Government eProcurement System		eProcurement System Government of India				
		Published Corrigendum Details				
		Date : 04-May-2022 04:38 PM				
		 Print				
Organisation Chain :	Indian Institute of Technology Ropar					
Tender ID :	2022_IITRP_681754_1					
Tender Ref No :	1691-21					
Tender Title :	Tender for Supply and Installation of Servo-Controlled Hydraulic Actuator					
Corrigendum Type :	Retender					
Corrigendum Document Details						
Corr.No.	Corrigendum Title	Corrigendum Description	Corrigendum Reason	Published Date	Document Name	Doc Size(in KB)
1	RE TENDER CORRIGENDUM	RE TENDER CORRIGENDUM	Minimum Bids Not Received	04-May-2022 04:38 PM	CORRRETENDERCLAR.pdf 	572.64

CORRIGENDUM

Reference Tender Notice No. 1691-21/CV-10179/ISIRD-II//PS/ & Tender id. 2022_IITRP_681754_1 for “Tender for Supply and Installation of Servo-Controlled Hydraulic Actuator”. In order to bring more clarity to the specifications (Annexure-A) the following clarifications have been made in the specifications and those are attached at (Annexure-A1).

Clarification on Actuator Placement and Load/Displacement Protocol for Tender Ref. Number 1691-21, Tender ID. 2022_IITRP_681754_1

Fig. 1 Representative Figure to Explain Mounting of Actuator (Source: Internet)

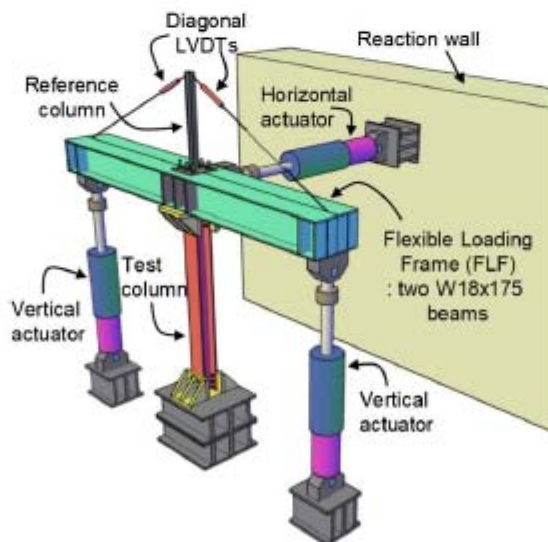
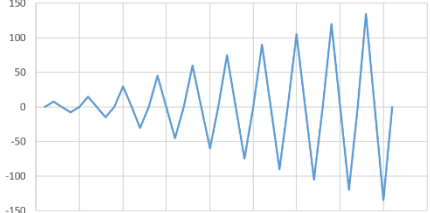
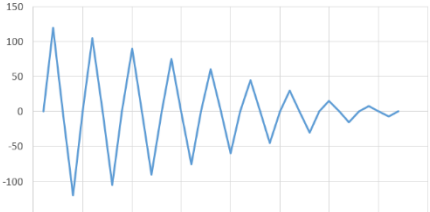
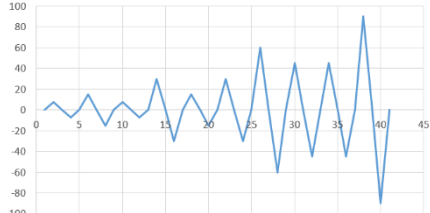
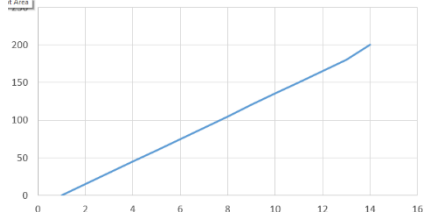
The actuator will be mounted (horizontally or vertically) on a reaction wall or frame at one end. Another end of the actuator will be attached to the specimens using a tie rods-based mechanical arrangement (see Fig. 1). The following points are to be noted in this regard:

1. The actuator and the control or hydraulic unit should operate at 5 meters distance. Meaning, the piping, wiring, and other wired or wireless connections should be designed such that the actuator mounted or placed up to 5 meters distance should be operational comfortably.
2. The actuator will be placed as used in the Civil Engineering Workshop at IIT Ropar Main Campus. A vendor who wishes to visit the lab facility may contact IIT Ropar/Indenter for assistance.
3. The abovesaid workshop has a 10-ton crane for the lifting and movement of objects. The actuator will also be handled using the same crane. Therefore, the actuator should be provided with a hook to lift and move the actuator within the laboratory.
4. The control and hydraulic units should be provided with Castor wheels and breaking arrangements to facilitate movement and stability whenever required.
